April 26, 2022
Medway Planning & Economic Development Board
Meeting

Public Hearing Continuation
Phytopia – 6 Industrial Park Road
Site Plan, Reduced Parking Special
Permit and Groundwater Protection
Special Permit

**Subject: Response to October 27, 2021 review comments from Tetra Tech
Phytopia, Inc.
Major Site Plan Review
6 Industrial Park Road
Medway, Massachusetts**

**Re: Phytopia Inc.
 Major Site Plan Review
 6 Industrial Park Road
 Medway, Massachusetts**

DRAWING: C9.1

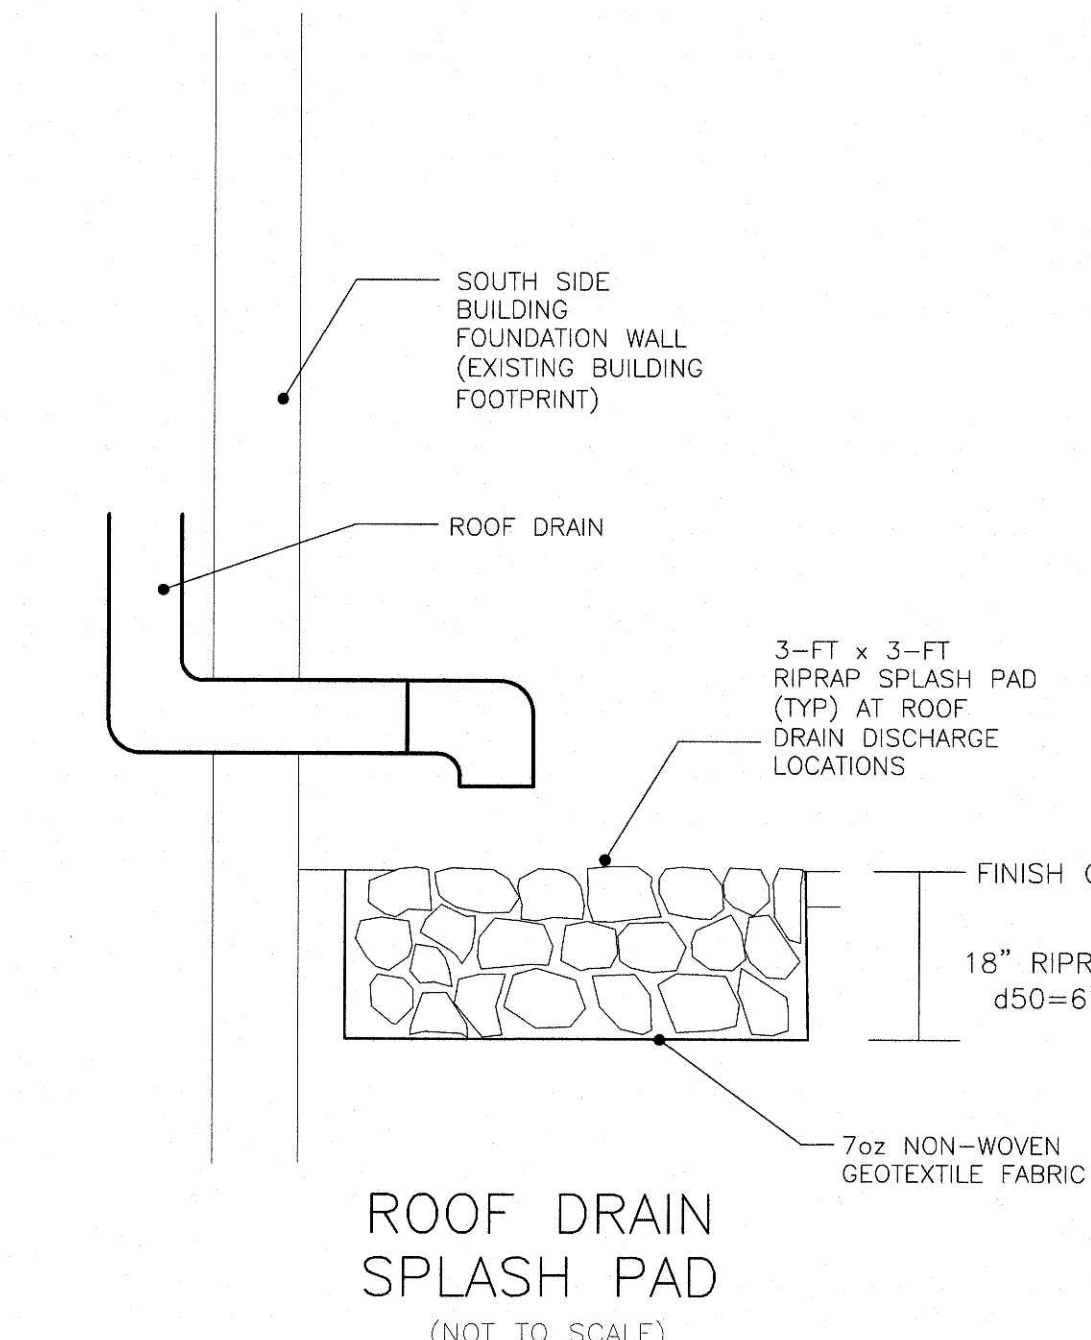
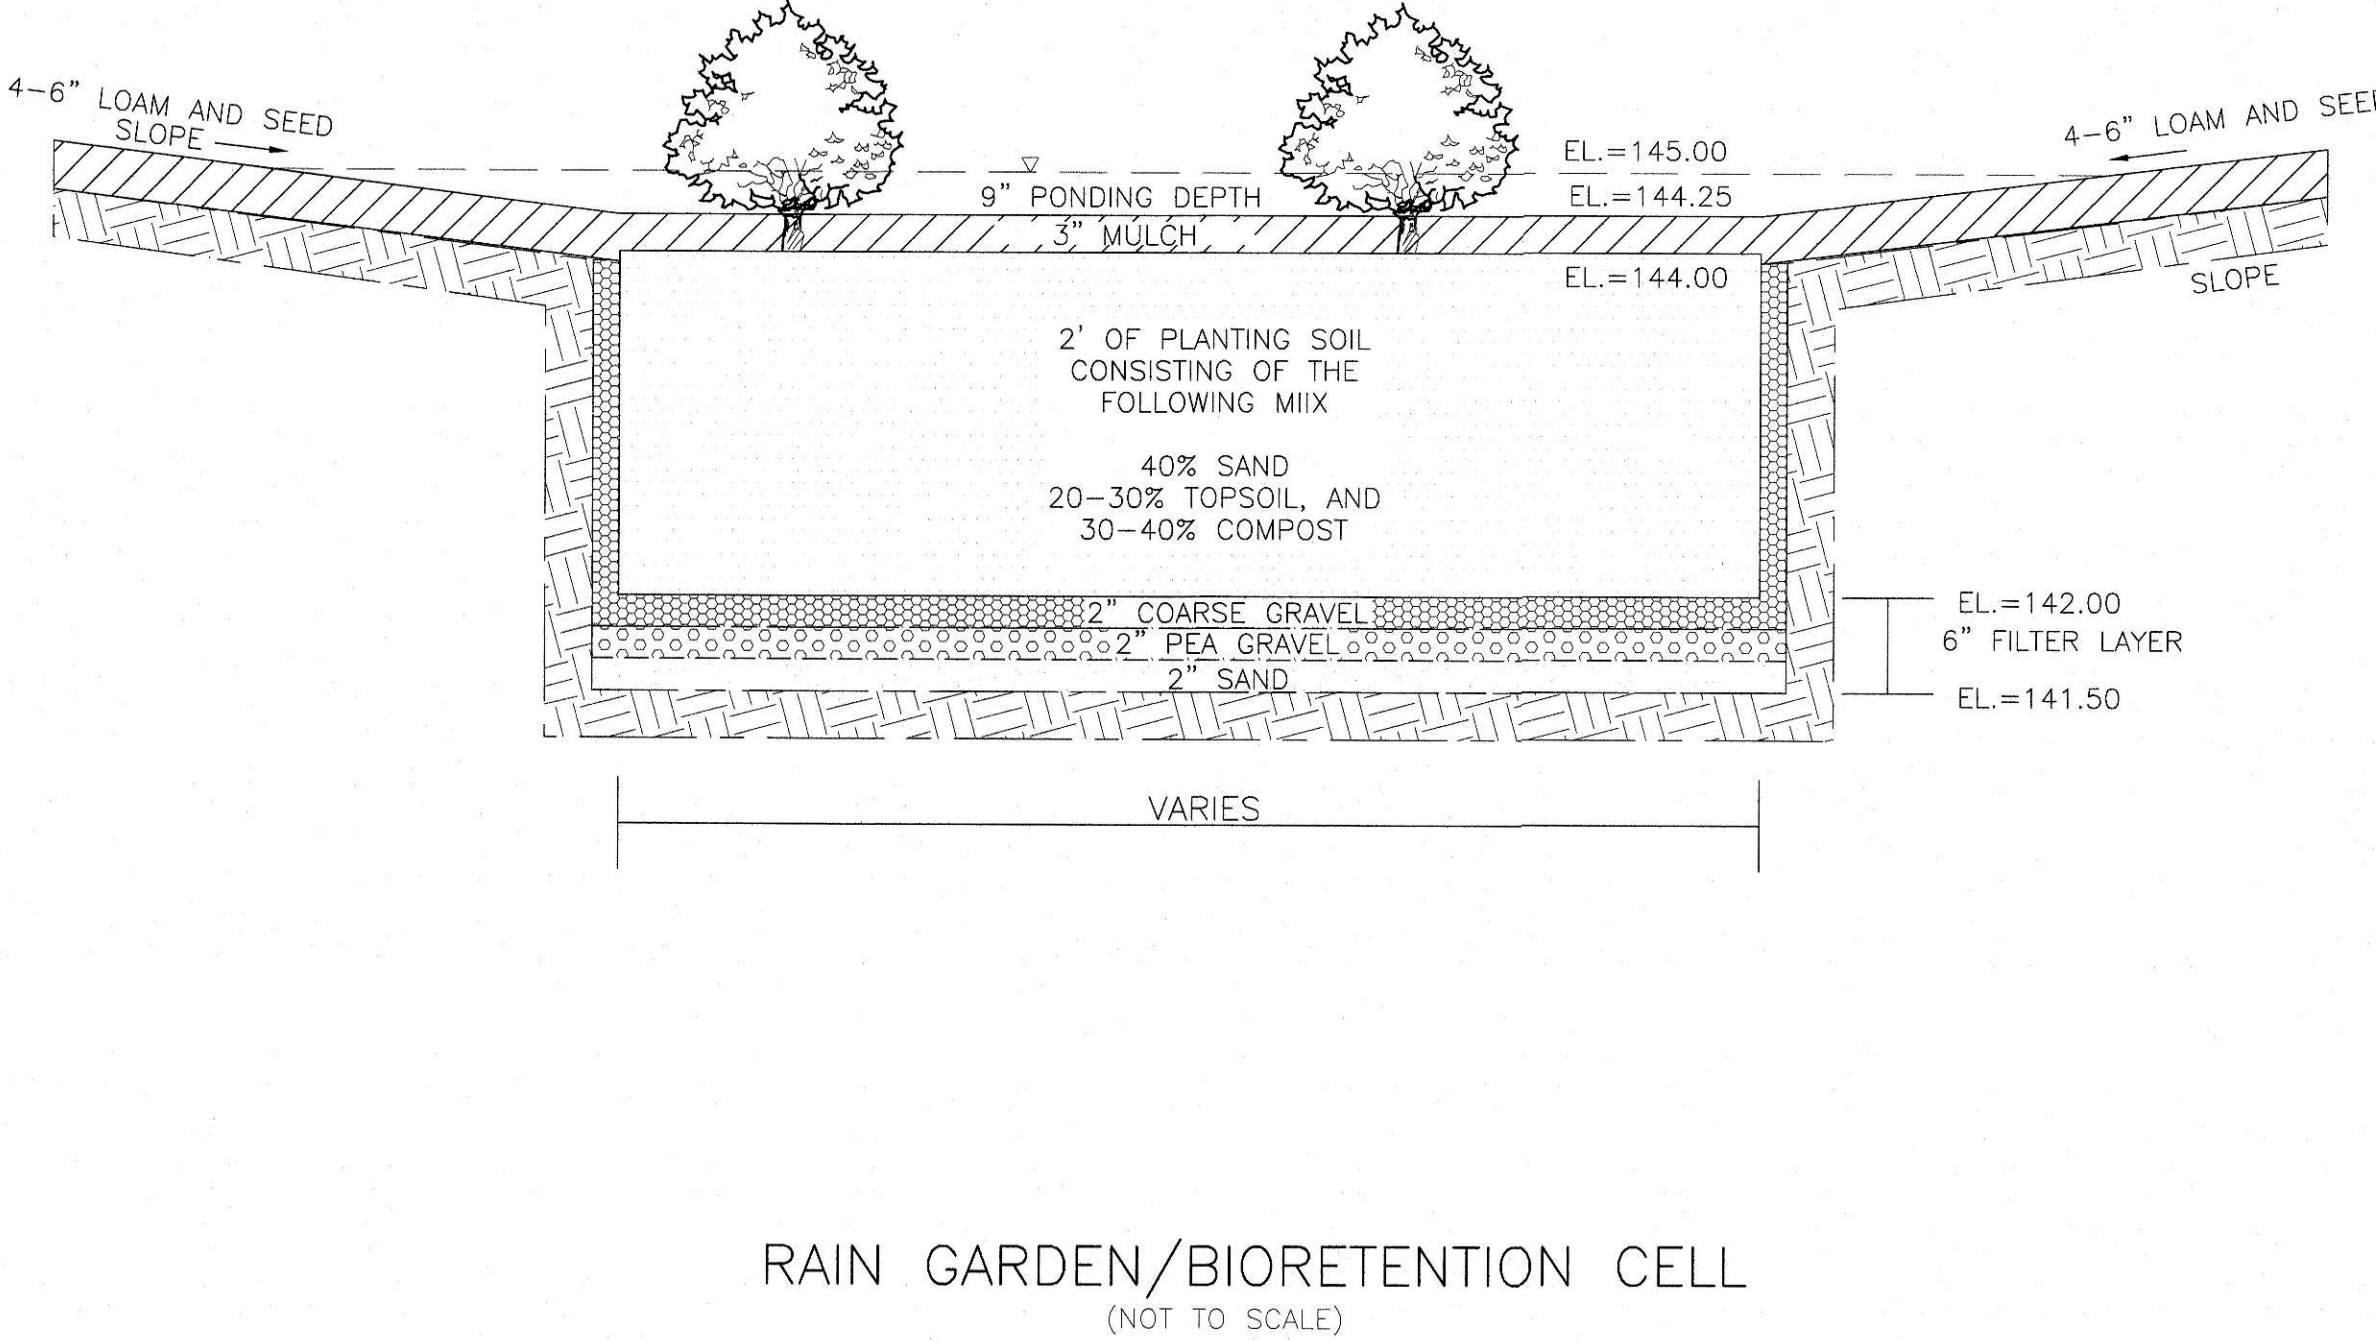
37. Mulch sock should be depicted in the "Siltfence with Mulch Sock" detail on the Construction Details Plan.

TT 10/27/21 Update: The detail does not appear to be correct as certain information is missing on the detail or is not showing up correctly when printed from CAD.

37. Mulch sock should be depicted in the "Siltfence with Mulch Sock" detail on the Construction Details Plan.
- *WSE 10/12/21 Response: Mulch sock is depicted on the Construction Details Plan, see sheet 9.*

The detail has been corrected. See sheet 10 of the plan set.

- *WSE 4/12/22 Response: The detail has been corrected. See sheet 10 of the plan set.*
 - **TT 4/22/22 Update: In our opinion, this comment is resolved.**

SHEET 14 OF 14

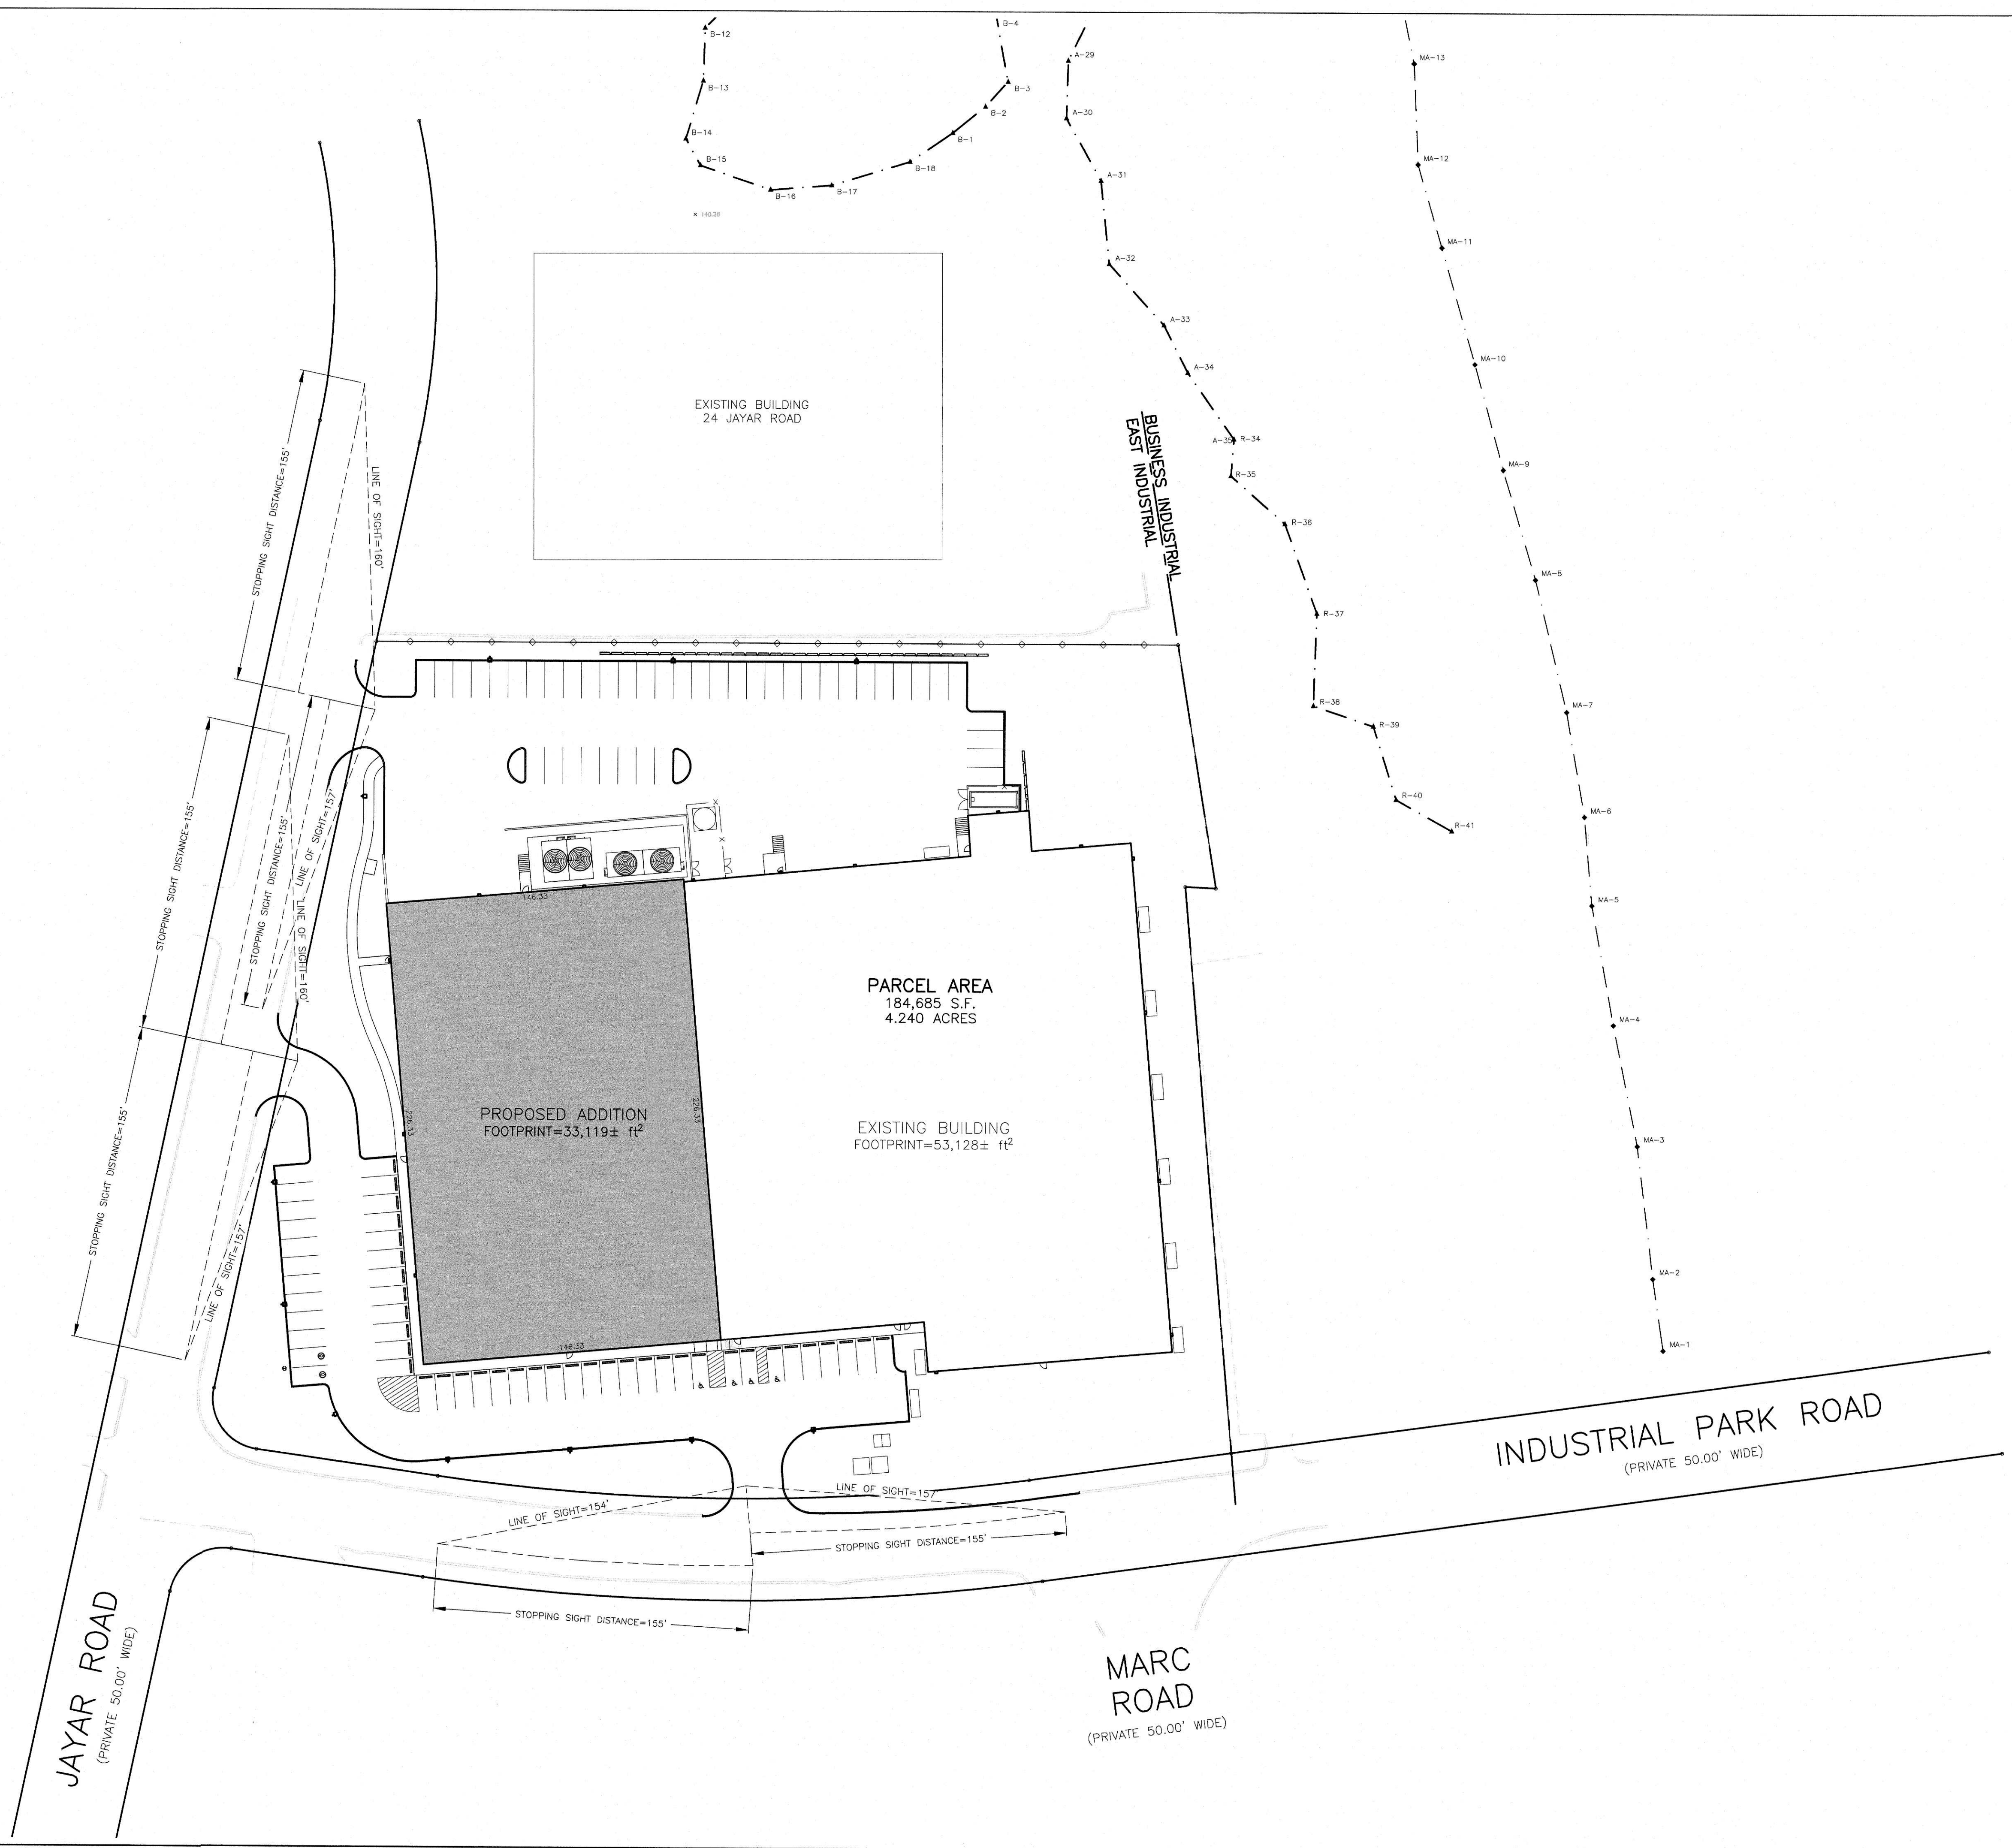
17. *The Plans do not include horizontal sight distances for the public roads at any of the four curb cuts at the Site. The Applicant has acknowledged this will be completed and filed at a later date. (Ch. 200 §204-5.D.16)*

Horizontal site distances have been provided, see sheet 12.
